## Commentary on Edgewater UDC 1/20/10 and 2/3/10 Submissions and Handout

### DESIGN ISSUES

PARKING RAMP ENTRANCE ILLUSTRATION

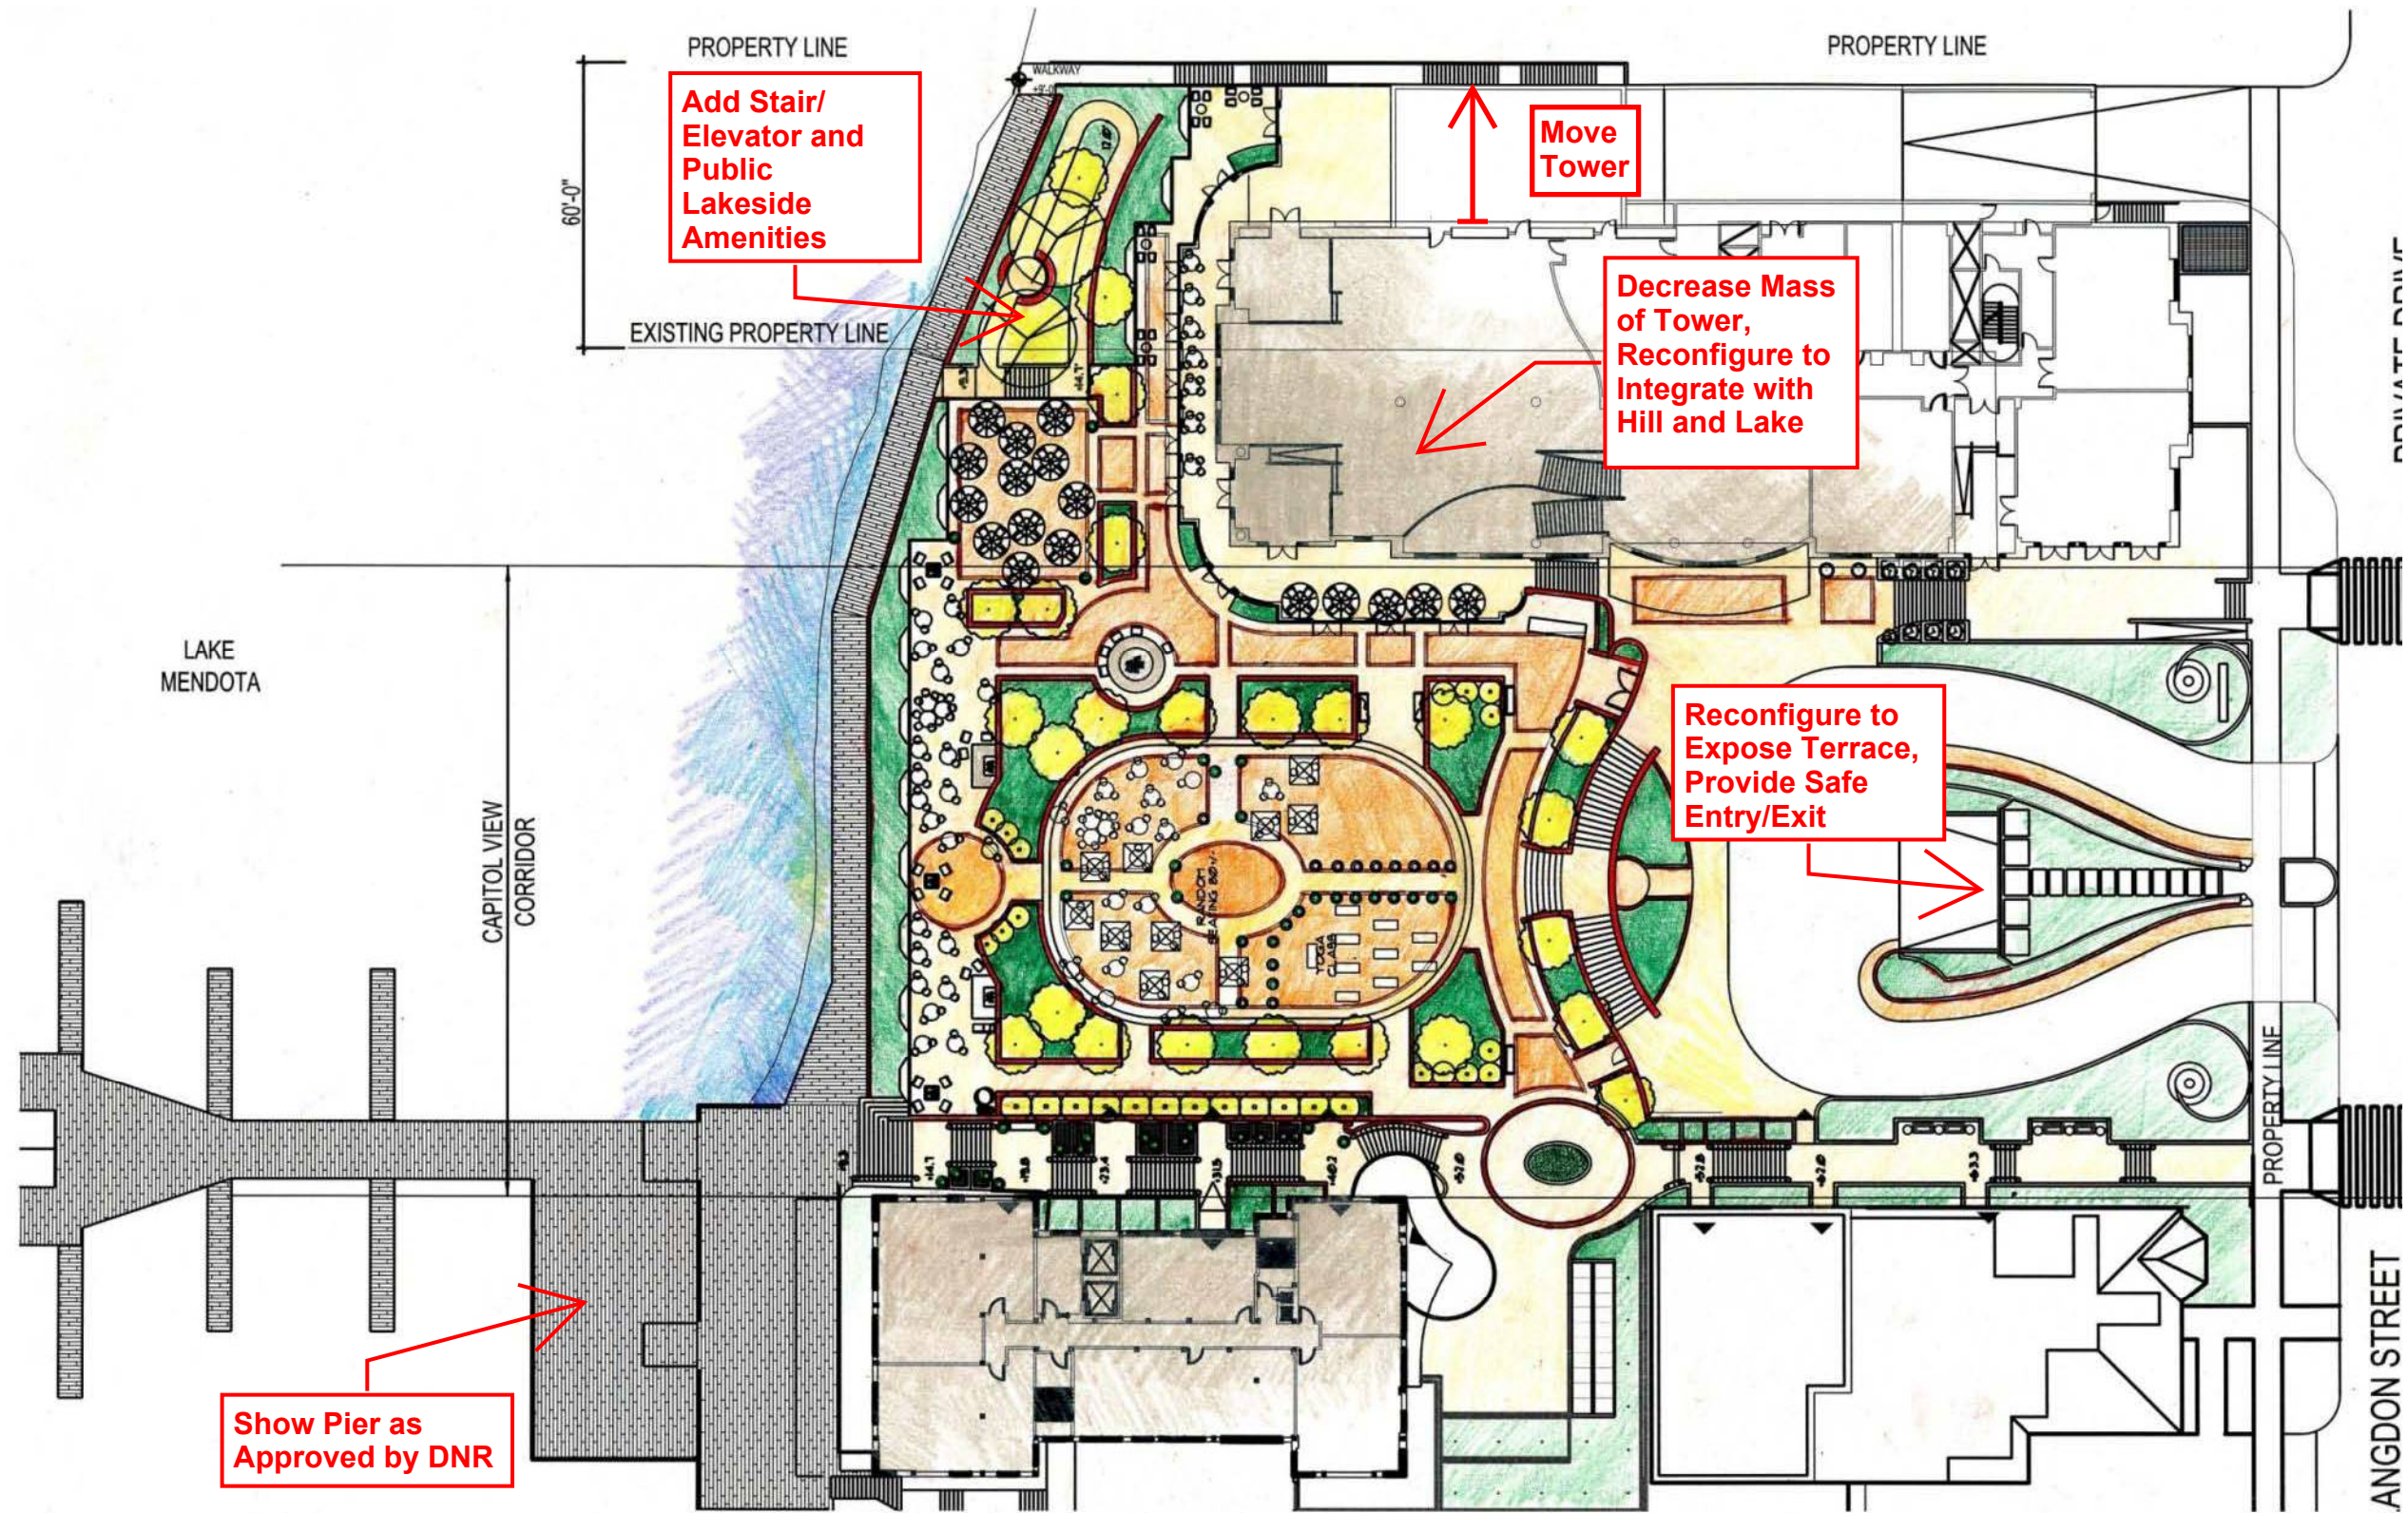
**The current configuration of the entrance to the parking ramp creates a significant bottleneck.** All traffic entering and leaving the parking ramp across each other's pathway at a critical stage in the and maneuvering area. Visibility of vehicles leaving the ramp is especially impaired. *The auto court needs reconfiguration.* (see "PARKING RAMP ENTRANCE ILLUSTRATION" at the end of this document)
